Access Compliance Report Public Rights-of-Way (Curb Ramps)

Intersection ID: 43303 Main Street: LANCASTER HY Cross Street: BALLANTYNE_GREEN_DR Location: W ADA ID: 4DFFA1C8285E Ramp Type: Perp Initial Pass/Fail: Fail **Overall Compliance: No Severity Score:** 22.5

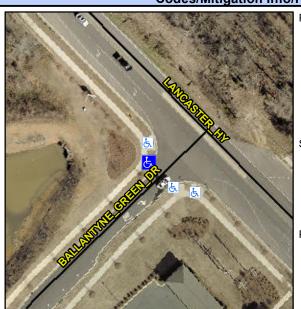
BALLANTYNE GREEN DR Street 1 Name Stop Condition-Street 2 StopSign Street 2 Name N/A Stop Condition-Street 1 N/A Possible Solutions: Remove & Replace Entire Ramp. Surveyor Notes: N/A PROW/ADA: Not Found, R304.5.1, R304.2.2, R304.5.3

Field Measurements/Component Compliance						
Compl	iance Description	Data	Comp	liance	Description	Data
N/A	Ramp Length (in)	96.0	No	Ram	Slope (%)	9.4
No	Ramp Width (in)	42.0	No	Ramp	XSlope (%)	3.1
N/A	Flare Type LT	N/A	N/A	Flare Type RT		N/A
N/A	Flare Slope LT (%)	N/A	N/A	Flare	Slope RT (%)	N/A
N/A	Flare Traversable LT?	N/A	N/A	Flare	Traversable RT?	N/A
N/A	Landing Length (in)	N/A	N/A	DWS	Provided?	N/A
N/A	Landing Width (in)	N/A	N/A	DWS	Contrast?	N/A
N/A	Landing Slope (%)	N/A	N/A	DWS	Length (in)	N/A
N/A	Landing X Slope (%)	N/A	N/A	DWS	Full Width?	N/A
N/A	Landing Curb? (Y/N)	N/A	N/A	DWS	Offset (in)	N/A
N/A	Shared Landing?	N/A				
N/A	Gutter Ponding?	N/A	N/A	Gutte	er Slope (%)	N/A
N/A	Gutter Lip Ht (in)	N/A	N/A	Gutte	er X Slope (%)	N/A
N/A	Painted X Walk1?	No	N/A	Paint	ed X Walk2?	N/A
	X Walk 1 Direction	To SE		X Wa	lk 2 Direction	N/A
N/A	X Walk 1 Width (in)	N/A	N/A	X Wa	lk 2 Width (in)	N/A
	X Walk 1 Slope (%)	3.9		X Wa	lk 2 Slope (%)	N/A

X Walk 1 X Slope (%)	0.4		X Wa	lk 2 X Slope (%)	N/A
N/A	Ramp inside XWalk1?	N/A	N/A	Ram	o inside XWalk2?	N/A
	Road Slope (%)	N/A	N/A	Clear	Space?	N/A
	Road X Slope (%)	N/A	N/A	Clear	Space to XWalk (in)	N/A
N/A	Any Obstructions?	N/A	N/A	Storn	n Grate/Utility Hazard?	N/A
	Obstruction Type			Storn	n Grate/Utility Type	
		N/A				N/A
			Yes	Surfa	ce Condition? (G/P)	Good
